UNITED STATES PATENT AND TRADEMARK OFFICE

APPLICATION NO.	FILING DATE	FIRST NAMED INVENTOR	ATTORNEY DOCKET NO.	CONFIRMATION NO.
10/681,321	10/09/2003	Tobie D. Hatfield	005127.00234	3379

Office Action Summary	Application No.	Applicant(s)	
	10/681,321	HATFIELD ET AL.	
	Examiner	Art Unit	
	Ted Kavanaugh	3728

DETAILED ACTION

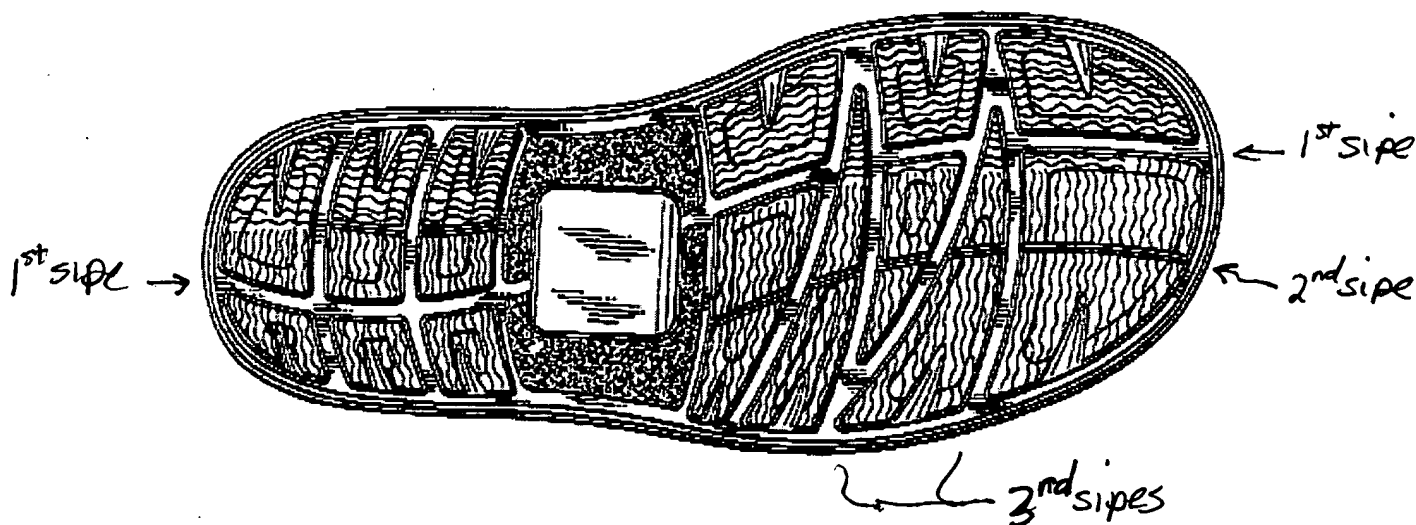
7. Claims 63-65 and 67,69 rejected under 35 U.S.C. 102(b) as being anticipated by D 378472 (Bramani).

Bramani shows a footwear having structure as claimed; see figure 2 below.

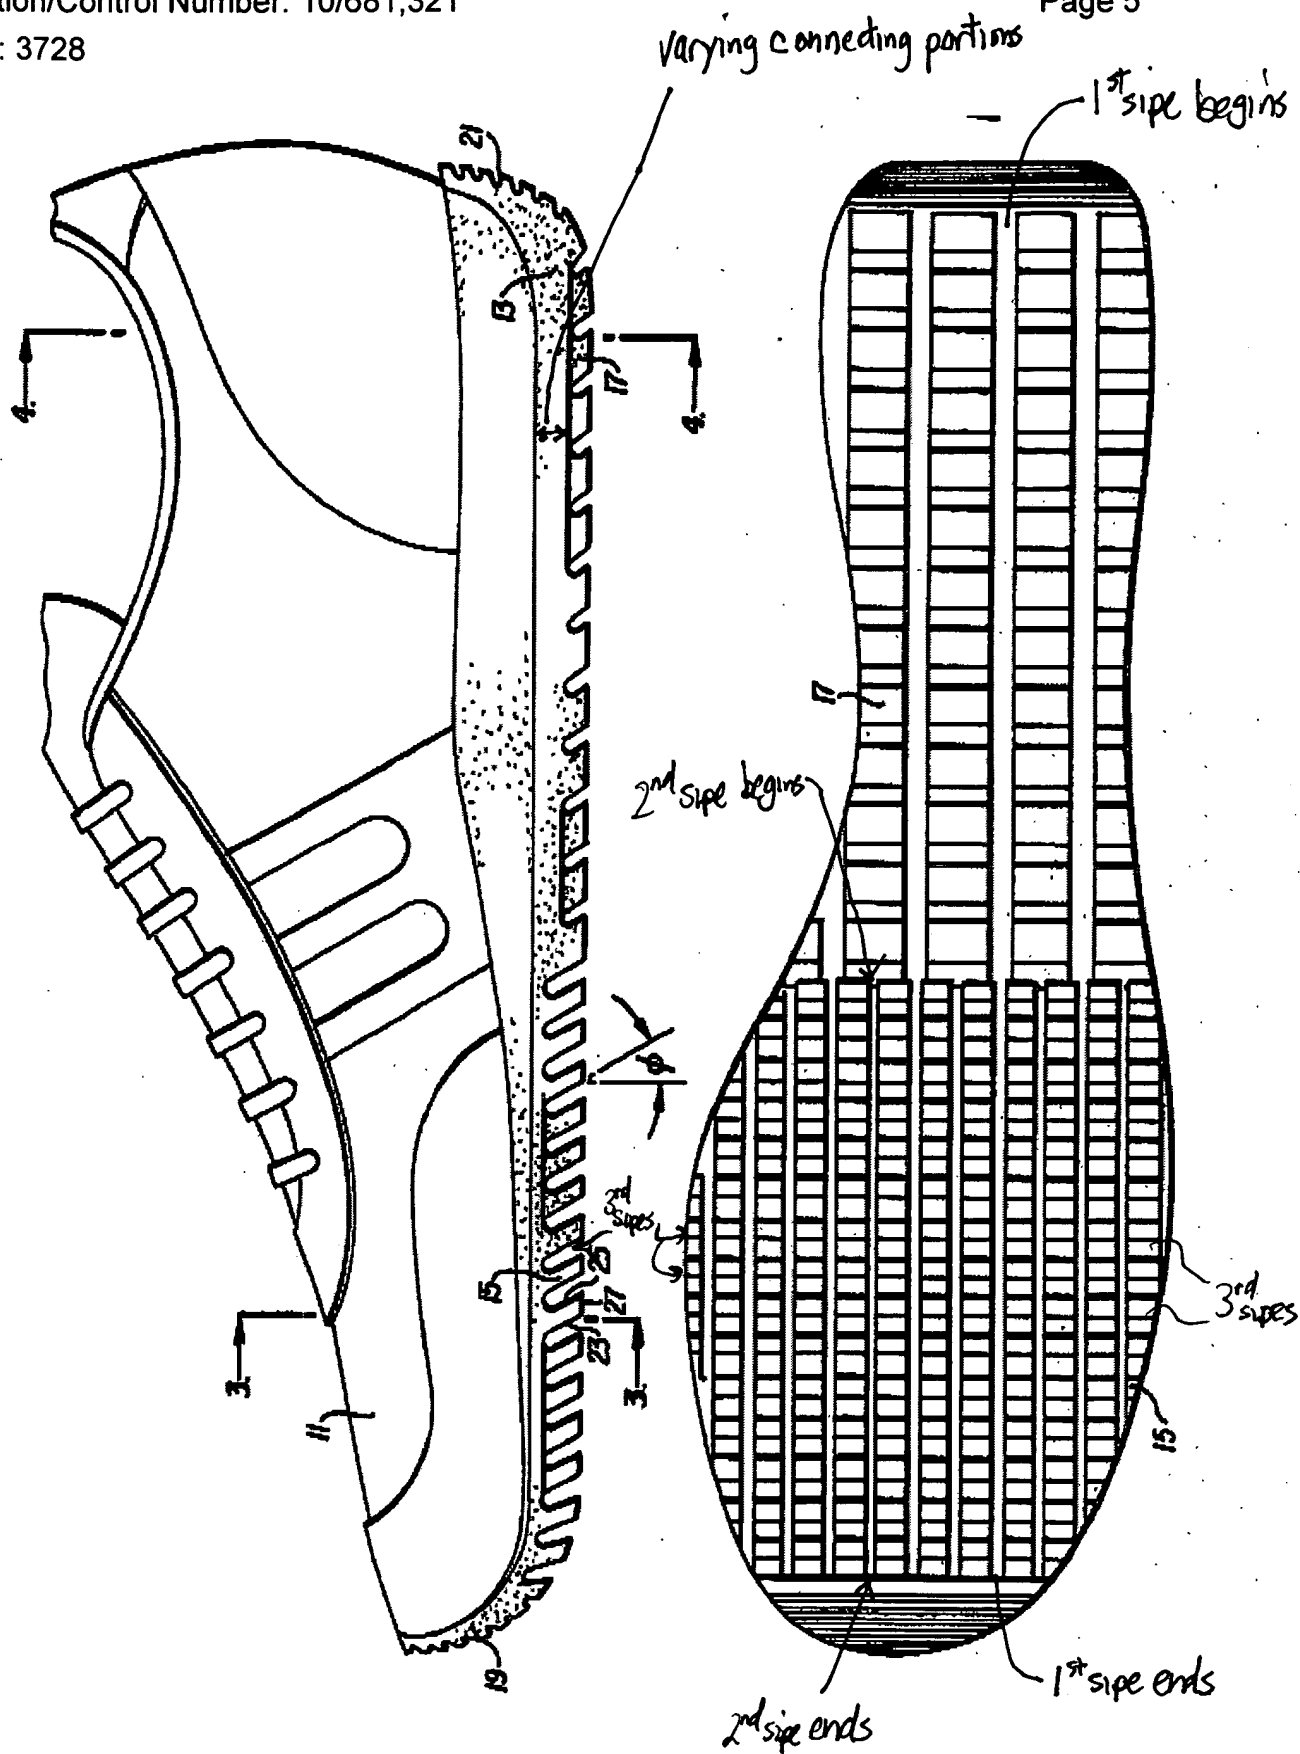
8. Claims 63-64, 67-69, 72 and 75 are rejected under 35 U.S.C. 102(b) as being anticipated by US 4309831 (Pritt).

Pritt teaches an athletic shoe comprising a sole having a plurality of discrete sole elements (cleats) and a plurality of sipes (see figure 2) extending upward into the sole, including a first sipe, a second sipe and a third sipe (see the figure below) substantially as claimed.

Regarding the "connecting portion", the sole as taught above includes a portion (the portion of the same sole) above the cleats to which all of the cleats are attached.

Regarding the first sipe having a curved configuration, see figure 6
